10. COA-055493-2019

2011 Venable Street

Commission of Architectural Review

STAFF REPORT

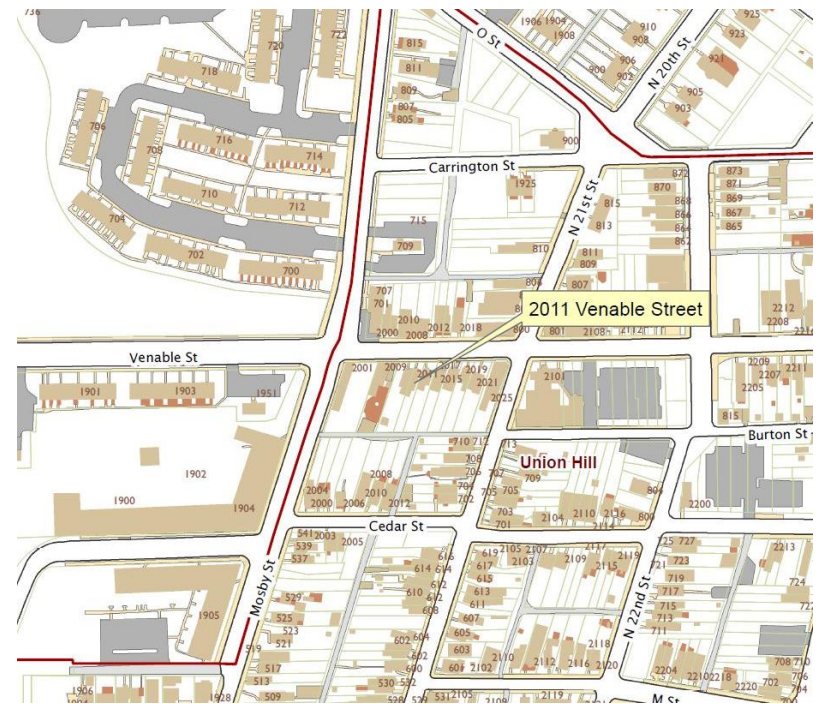
Construct a new, covered front porch and a rear deck and stairs.
